**STAFF REPORT:** 10/08/2025 REGULAR MEETING

**APPLICATION NUMBER:** HDC2025-00551

**ADDRESS:** 255 E. FERRY

**SCOPE:** ALTER AND REHABILITATE DWELLING, ERECT SIDE PORCH

*Photo from application of existing condition*

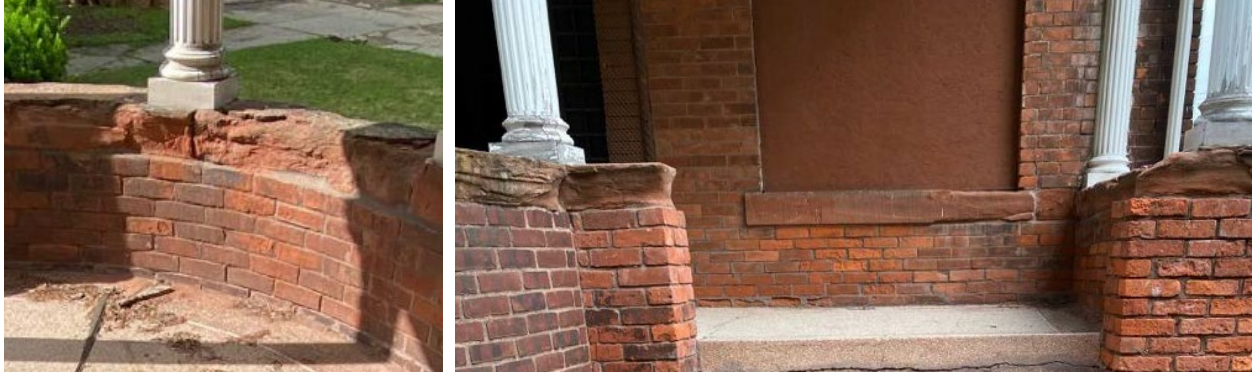
- The existing historic terrazzo design, featuring tesserae that separate the two tones of terrazzo, reflects the style commonly used in the United States from the late 19th to early 20th century.

- Italian immigrants introduced terrazzo to the United States, with the first documented installation taking place in 1890 at the Vanderbilt residence in New York City. This event helped establish the technique as an artisanal skill, thanks to the expertise of Italian craftsmen. The installation in the home of one of America's wealthiest families cemented terrazzo's reputation as a high-end and exceptional material. Since this house was built in 1893, it's likely that the terrazzo was installed by such a skilled artisan. By the early 1900s, a wave of Italian immigration brought even more trained terrazzo workers to the U.S., further spreading and popularizing the technique.

- It is staff's opinion that the existing, two-toned terrazzo, separated by a tesserae border, is a distinctive and historic character-defining feature.

- The two-tone terrazzo and tesserae flooring on the front porch shall be replicated.
- When the vinyl siding is removed, photos of the existing conditions shall be submitted for staff review before moving forward with any work. Any existing historic siding is to be restored, with any damaged or missing siding to be replaced in-kind.
- The following shall be submitted for staff review and approval:
  - The height of the proposed wood railing along the edge of the new porch roof
  - The finish/color of the aluminum-clad windows
  - The material of the proposed custom doors
  - The design and materiality of the attic dormer door
  - The design and materiality of the storm windows

*Site plan from application of proposal*

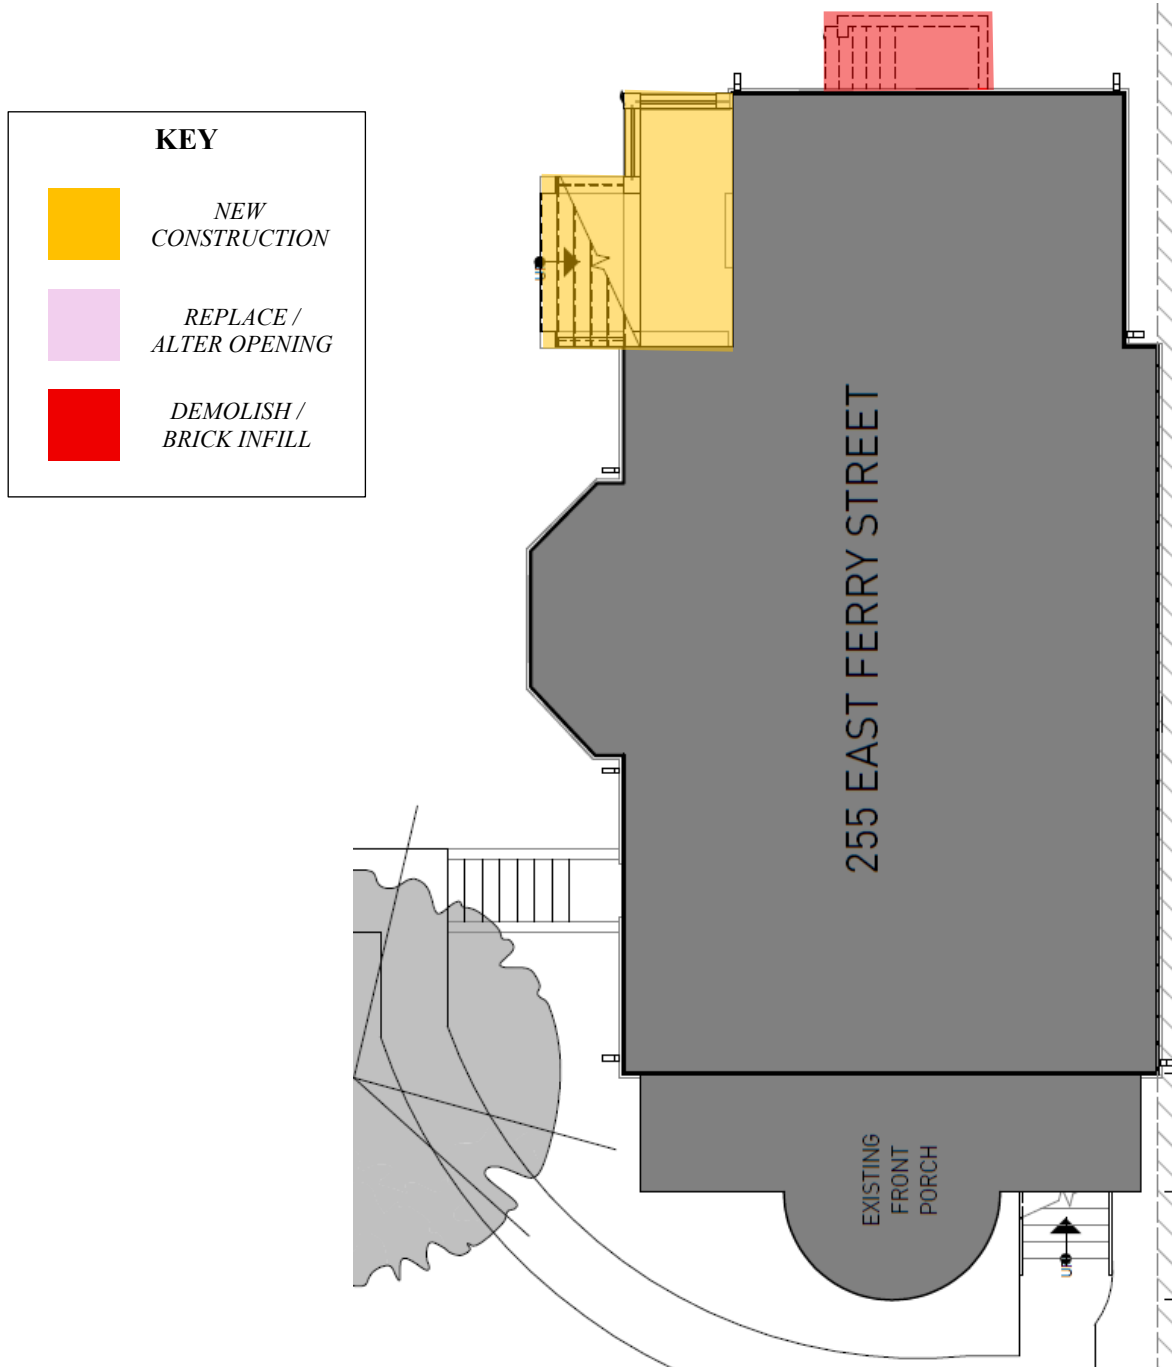
- The applicant proposes to convert two existing windows into doors by removing the brick masonry below the window sills, while maintaining the existing openings. This alteration is part of a proposed side porch addition located within a recessed section of the house. The new porch will be wood-framed, featuring partial brick columns, a simple wood railing, a wood roof structure, and an additional wood railing along the edge of the porch roof.

- Based on the 1897 Sanborn map, which shows other houses on the same street with similar porches located in rear or corner recesses, staff finds that the proposed construction of a new porch at the recessed rear/side corner is generally appropriate to the historic character of the house. However, staff does note the following concerns:

*Elevation from application of proposal*

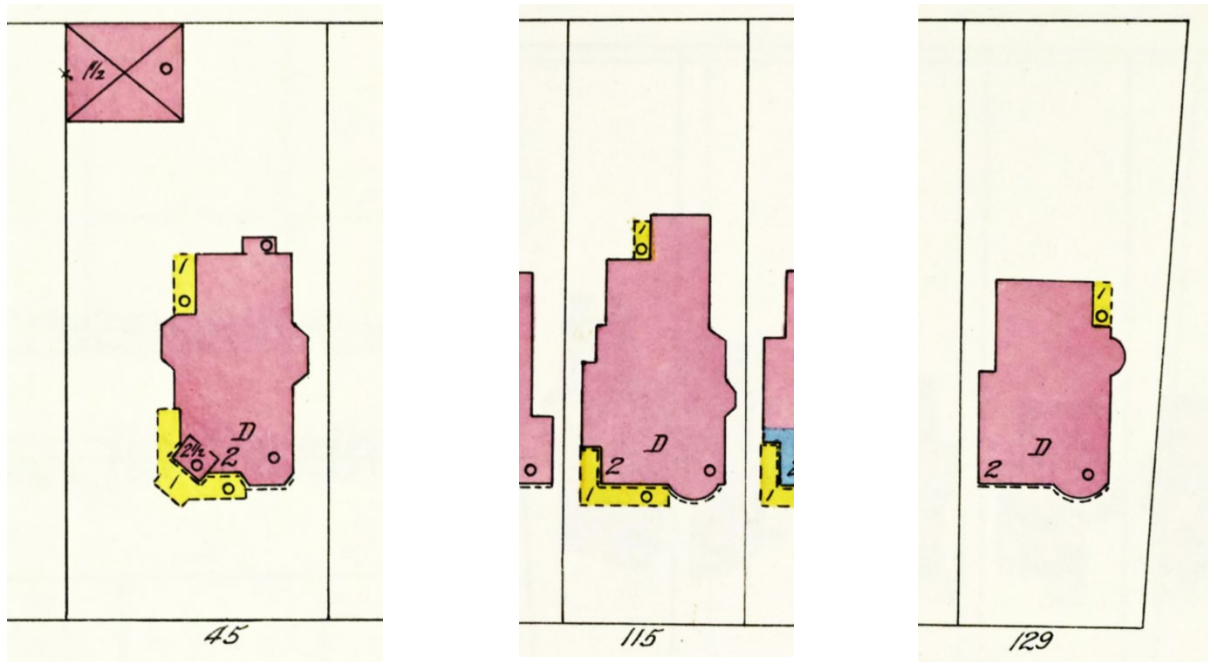
- The current application lacks the height of the proposed wood railing along the edge of the porch roof.

*Photo from application of existing condition*

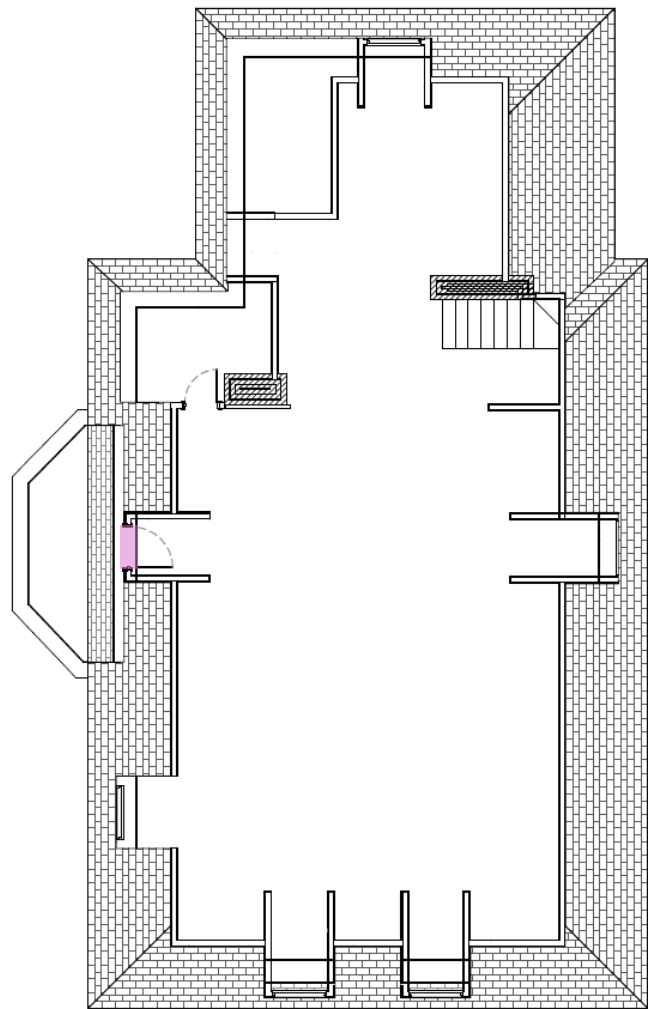
- The applicant proposes to replace the existing, non-historic door at the attic dormer, but staff notes that they do not specify what the replacement door is.
